REPLACEMENT SYSTEM VARIANCE REQUEST

GENERAL INFORMATION		Town of <u>AUGUSTA</u>
Permit No. <u># 3927</u>		Date Permit Issued <u>5/14/98</u>
Property Owner's Name: <u>DONALD LEWIS</u>		Tel. No.: <u>622-7921</u>
System's Location: <u>WEST RIVER ROAD (RTE 104)</u>	<u>AUGUSTA</u>	
Property Owner's Address: <u>RFD 3 BOX 18</u>		
(if different from above) <u>AUGUSTA, ME 0433 0</u>

SUBSURFACE WASTEWATER DISPOSAL SYSTEM APPLICATION

SUBSURFACE WASTEWATER DISPOSAL PLAN

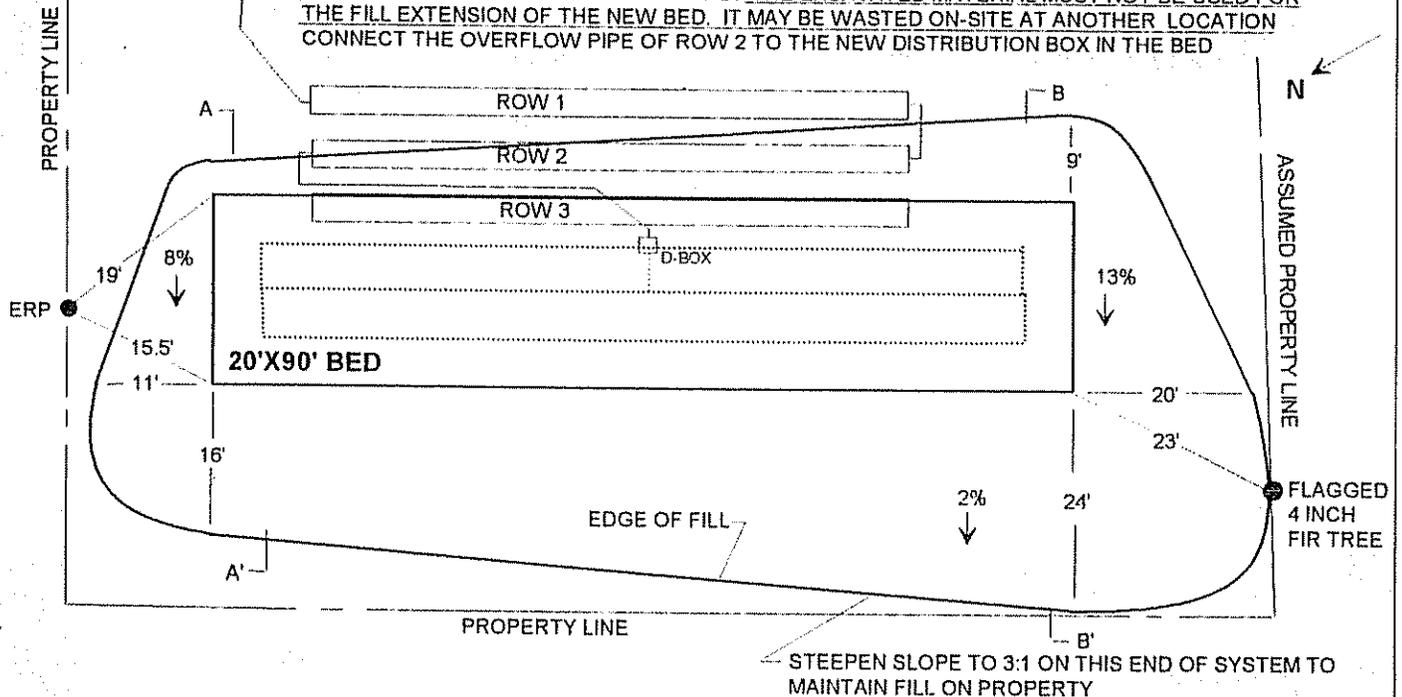
1. Fill extension Grade - to 3:1 **REDUCE FILL EXTENSION ON ONE END OF BED TO LESS THAN 4:1 TO MAINTAIN FILL ON PROPERTY**
- 2.
3. **REDUCE SEPARATION DISTANCE TO APPROXIMATELY 12 INCHES TO MAINTAIN FILL ON PROPERTY**

A SUBSTANTIAL AMOUNT OF FINE-TEXTURED FILL WAS USED IN THE FILL EXTENSION FOR THE CHAMBER SYSTEM. THIS FILL, VARYING FROM 4 INCHES DEEP TO 2 FEET DEEP, MUST BE REMOVED FROM THE DISPOSAL AREA. EXCAVATE ALL FINE-TEXTURED FILL UNDER NEW DISPOSAL BED, IN FILL EXTENSION AREA, AND UP TO AND INCLUDING ROW 3 OF THE CHAMBER SYSTEM. REMOVE ALL CONTAMINATED SOIL UNDER ROW 3 AND ALL FINE-TEXTURED FILL. REPLACE WITH GRAVELLY COARSE SAND. THE EXCAVATED MATERIAL MUST NOT BE USED FOR THE FILL EXTENSION OF THE NEW BED. IT MAY BE WASTED ON-SITE AT ANOTHER LOCATION CONNECT THE OVERFLOW PIPE OF ROW 2 TO THE NEW DISTRIBUTION BOX IN THE BED
